Request for Class II Permissive Change(C2PC)

FCC ID: [VG8XM262AYY2M392](#)

Please be notified that we, the undersigned, **Guangdong Midea Kitchen Appliances Manufacturing Co., Ltd.** declare that the reasons for this class II permissive change are as below:

This is a C2PC application for which the previous grant was issued on [06/20/2023](#).

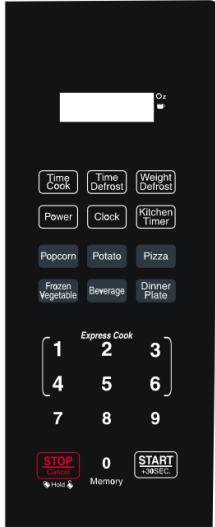
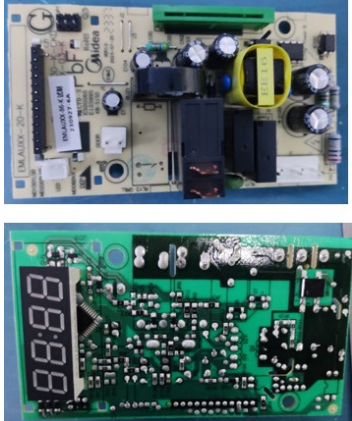
No.:	Original	New	Difference(s)
1			<p>Keypad: Updated front keypad to accommodate child lock function (Child resistant oven door function)</p>
2			<p>Mother board: Modified the peripheral circuit (non-RF circuit) and some individual components and PCB layout. The magnetron and other circuit are exactly same as before</p>
